Intel[®] Mobile Pentium[®] III Processor Specification Update

Release Date: May 2000

Order Number: 245306-007

Figure 7. BCLK Timing Waveform

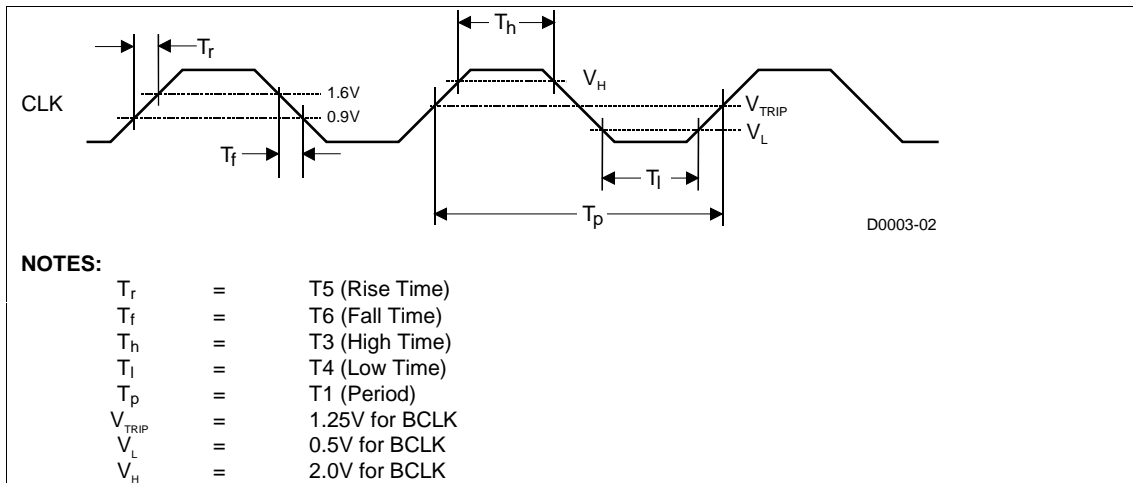
For B0 step processors, the $V_{IH,BCLK}$ Min spec is changed to 2.0V (from 1.7V for A2 step) and $V_{IL,BCLK}$ Max spec is changed to 0.5V (from 0.7V for A2 step). Due to this, new values are specified for BCLK high and low times for B0 step processors. These modifications affect corresponding specs in Table 13, Table 14, Table 24, and Figure 7 in *Mobile Pentium® III Processor in BGA2 and Micro-PGA2 Packages datasheet* (Order Number 245302-002).

The following tables and figures highlight the above mentioned BSEL[1:0] and BCLK specs modifications made for B0 step processors:

Symbol	Parameter	Min	Typ	Max	Unit	Figure	Notes
	System Bus Frequency		100		MHz		
T1	BCLK Period		10		ns	Figure 7	Note 2
T2	BCLK Period Stability			± 250	ps		Notes 3, 4
T3	BCLK High Time	2.70			ns	Figure 7	at >2.0V
T4	BCLK Low Time	2.45			ns	Figure 7	at <0.5V
T5	BCLK Rise Time	0.175		0.875	ns	Figure 7	(0.9V – 1.6V)
T6	BCLK Fall Time	0.175		0.875	ns	Figure 7	(1.6V – 0.9V)

Figure 4. BCLK Waveform at the Processor Core Pins

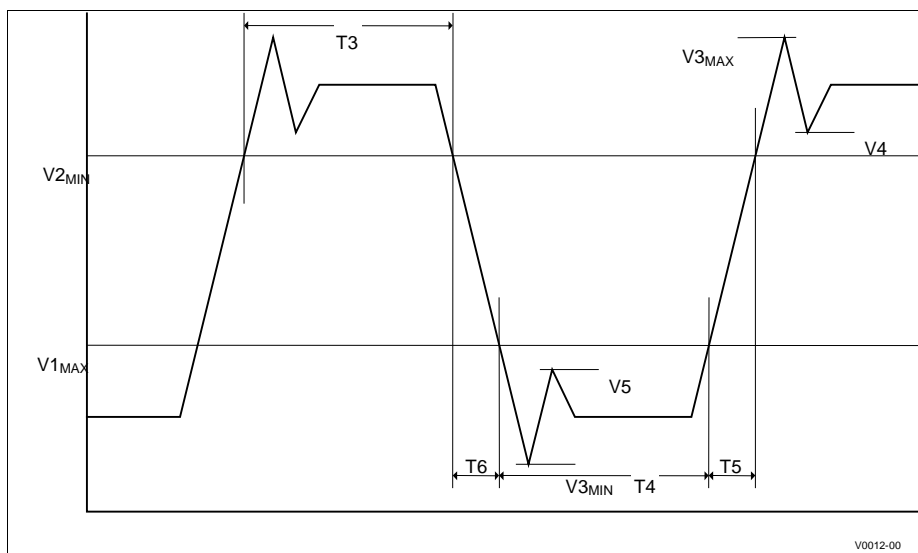
In Table 18, “BCLK Signal Quality AC Specifications at the Processor Core” of the *Intel® Pentium® III Processor Mobile Module: Mobile Module Connector 2 (MMC-2)* datasheet, and Table 19 of the *Intel® Pentium® III Processor Mobile Module: Mobile Module Connector 2 (MMC-2) Featuring Intel® SpeedStep™ Technology* datasheet, Note 3 has been updated. Figure 4 “BCLK Waveform at the Processor Core Pins” has also been updated. See below.

3. The rising edge ringback voltage specified is the minimum absolute voltage that the BCLK signal can dip back to after the BCLK signal passes the $V_{IH,BCLK,MIN}$ (rising) voltage limits. The falling edge ringback voltage specified is the maximum absolute voltage that the BCLK signal can dip back to after the BCLK signal passes the $V_{IL,BCLK,MAX}$ (falling) voltage limits.
